Groundwater Transfer Review Summary Form

Transfer/PA # T- 13697

Application: T-13697

Applicant Name: Case Family LLC

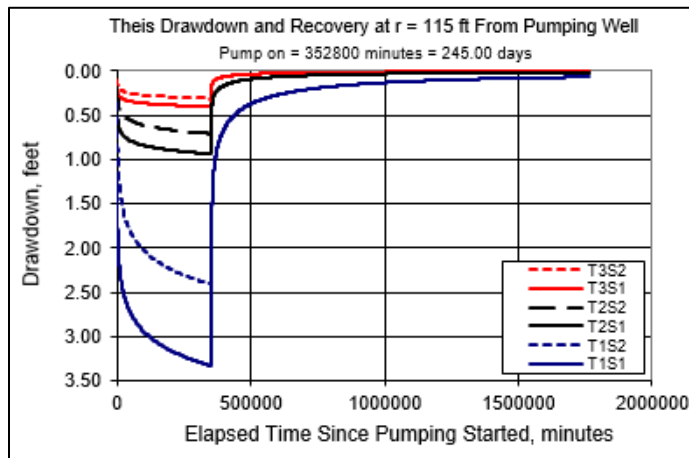
4. a) Will this proposed change, at its maximum allowed rate of use, likely result in an increase in interference with **another ground water right**?
☒ Yes ☐ No Comments: Proposed POA LINN 4614 is 115 feet from LINN 4606, which is authorized under groundwater claim GR-919. The distribution of pumping between the four wells that would result from approval of this transfer is unknown.

☐ Yes ☒ No If yes, explain: Given the fairly low authorized rate for GR-1543 (0.1114 CFS) added to proposed use resulting from T-13693 (GR-2289 - 0.4456 CFS) and the combination of high transmissivity and high storativity of the unconfined alluvial aquifer, anticipated drawdown assuming all pumping under these rights occurs at LINN 4614 is minimal at LINN 4606, with a range of scenarios producing less than 3.5 feet of likely drawdown.
